SUBJECT: Grand Gulf Nuclear Station  
Unit 1  
Docket No. 50-416  
License No. NPF-29  
Suppression Pool Makeup  
System Initiation Setpoint  
Proposed Amendment to the  
Operating License  
(PCOL-89/05)  
AECM-89/0077

A. SUBJECT

1. NL 89/05 Suppression Pool Makeup System Initiation Setpoint
2. Affected Technical Specifications
  - a. Plant Systems Actuation Instrumentation, Table 3.3.8-1, Item 3.e - Page 3/4 3-106.
  - b. Plant Systems Actuation Instrumentation Setpoints, Table 3.3.8-2, Item 3.e - Page 3/4 3-108.
  - c. Plant Systems Actuation Instrumentation Surveillance Requirements, Table 4.3.8.1-1, Item 3.e - Page 3/4 3-109.
  - d. Plant Systems Actuation Instrumentation Bases, 3/4.3.8 - Page B 3/4 3-6.

Figure 1

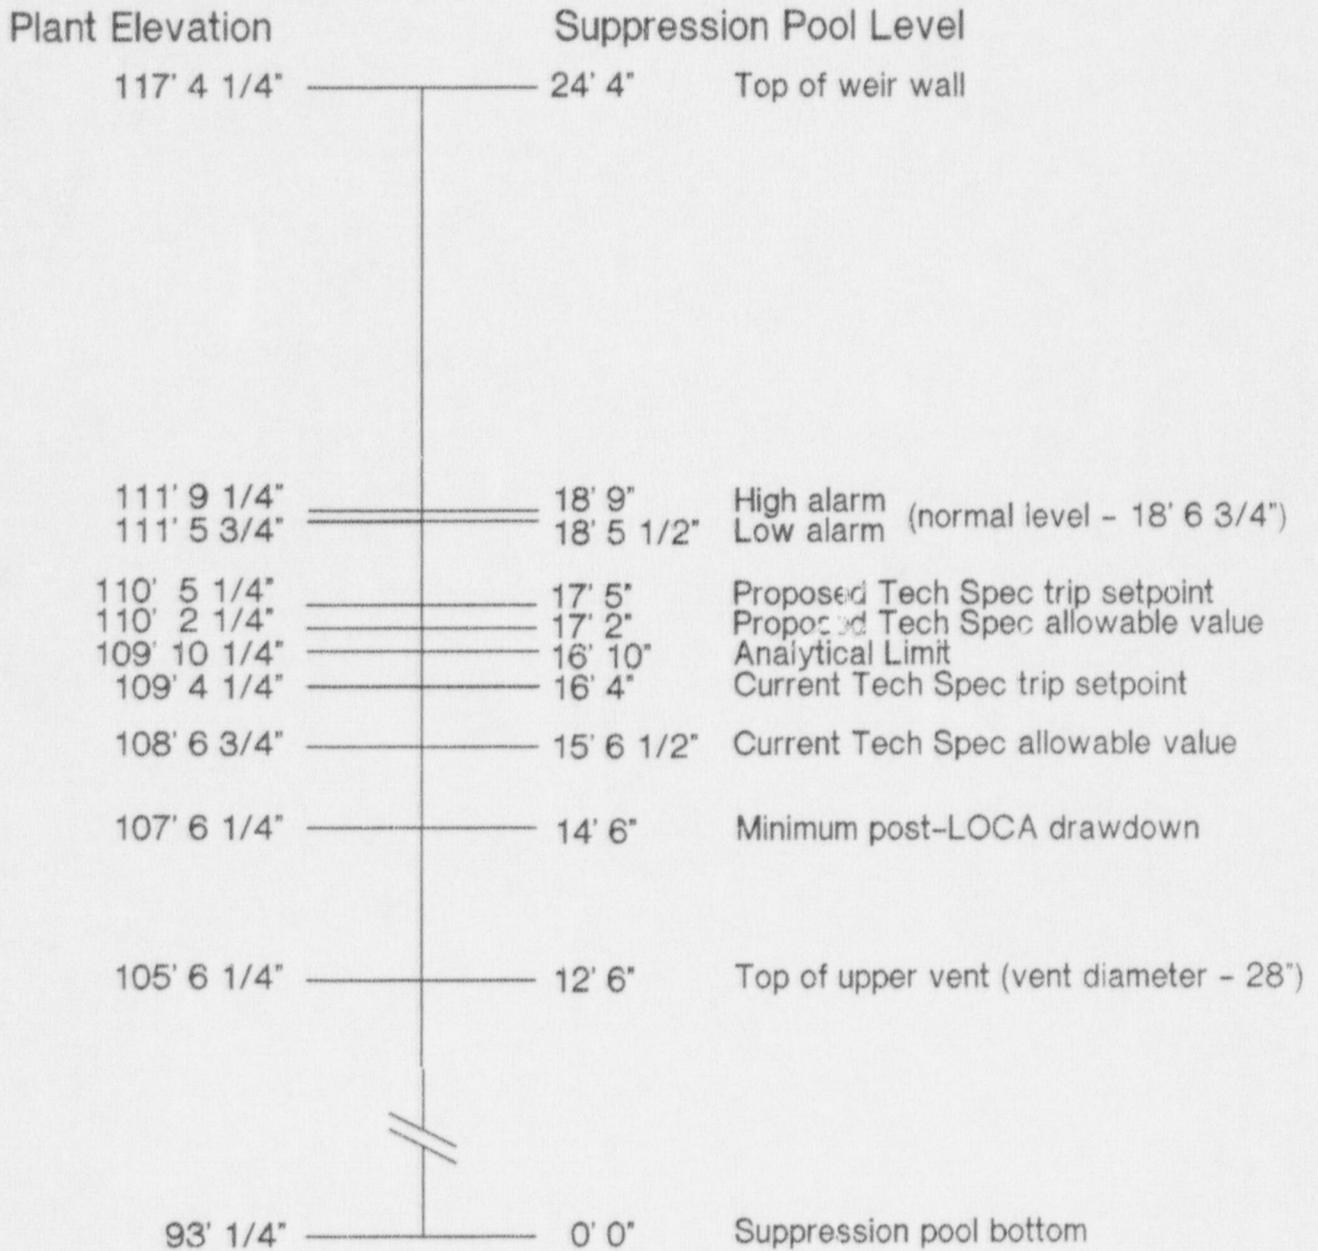
SERI is currently developing System Design Criteria (SDC) for selected GGNS plant systems. The SDC document is a synthesis of the various applicable design specifications for each system. During the preparation/review of the Suppression Pool Makeup (SPMU) SDC, SERI identified a discrepancy regarding the SPMU system initiation setpoints contained in Technical Specification (TS) Table 3.3.8-2. This Technical Specification was added in Amendment 13 with the current trip setpoint (16 feet 4 inches) and allowable value (15 feet 6.5 inches) apparently incorrectly calculated and nonconservative with respect to the analytical limit of 16 feet 10 inches. This could potentially lead to the suppression pool water coverage of the top drywell vent to be less than the required 2 feet post-LOCA. SERI is currently evaluating this potential in accordance with the requirements of 10CFR50.73. Figure 1 illustrates the various suppression pool water levels of interest along with references to plant elevation.

- a. Technical Specification Tables 3.3.8-1, 3.3.8-2, and 4.3.8.1-1 Item 3.e, Suppression Pool Water Level - Low, is revised to specifically describe the signal received (Suppression Pool Water Level - Low Low).
- b. The suppression pool low-low water level trip setpoint and allowable value listed in Table 3.3.8-2, Item 3.e are changed to be greater than or equal to 17 feet 5 inches and 17 feet 2 inches, respectively.
- c. Bases 3/4.3.8 is revised to correct the reference elevation of the surface floor of the suppression pool.

7. TS 3.6.3.4 contains the requirements for the SPMU system. TS 3.3.8 gives the requirements for the SPMU system actuation instrumentation. The proposed amendment will change the current suppression pool water level low-low trip setpoint and allowable value from 16 feet 4 inches and 15 feet 6.5 inches to 17 feet 5 inches and 17 feet 2 inches, respectively. Both of these changes are overall more conservative than the current TS values since the SPMU system will actuate at a higher suppression pool water level than allowed by the current TS.
